Mazda North American Operations Irvine, CA 92618-2922

REFERENCE NO: RF-13-08 DATE: June 28, 2013

SUBJECT: 2012-2013 MAZDA3 - FRONT SEAT TRIM ATTACHMENT CHANGE

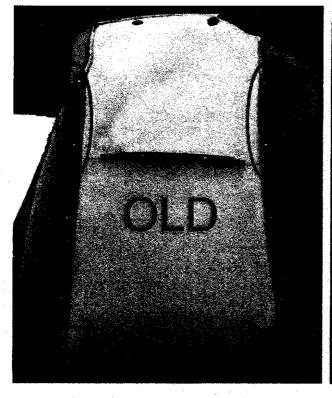
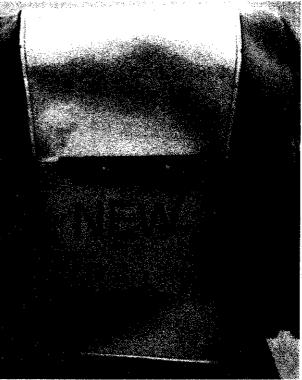
The attaching points have been reduced on replacement front seat back trim parts. This is a running change, meaning the same part number may arrive in old or new style until the old stock is exhausted. DO NOT return the seat trims missing the upper attaching points — they are not defective.
